NUMBER: B389R1085-0

SERVICE BULLETIN

Ride: 50' CARROUSEL

Subject: Hydraulic Motor Cavitation

KIT 389R1085-0

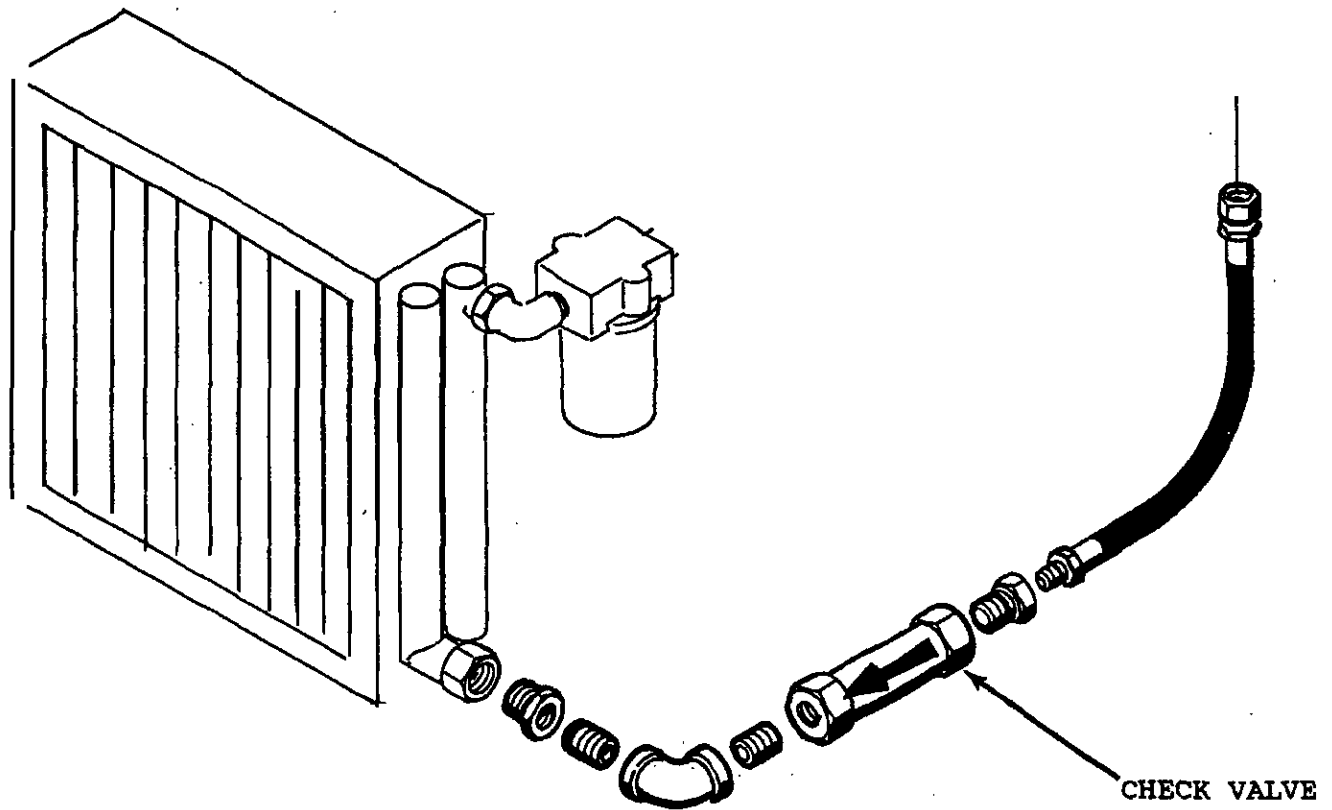
Chance Rides, Inc. has become aware of at least one 50' CARROUSEL amusement ride which has experienced cavitation to the hydraulic motor. A rework kit has been developed which when properly installed will help keep the motor supplied with oil. Chance Rides, Inc. requires all owners of the above noted rides to order and install kit number K389R1085-0 which contains all parts necessary to rework one ride.

The above noted, kit must be installed per the instructions which will accompany the kit and the attached Certification Of Compliance returned within 15 days after receipt of the kit.
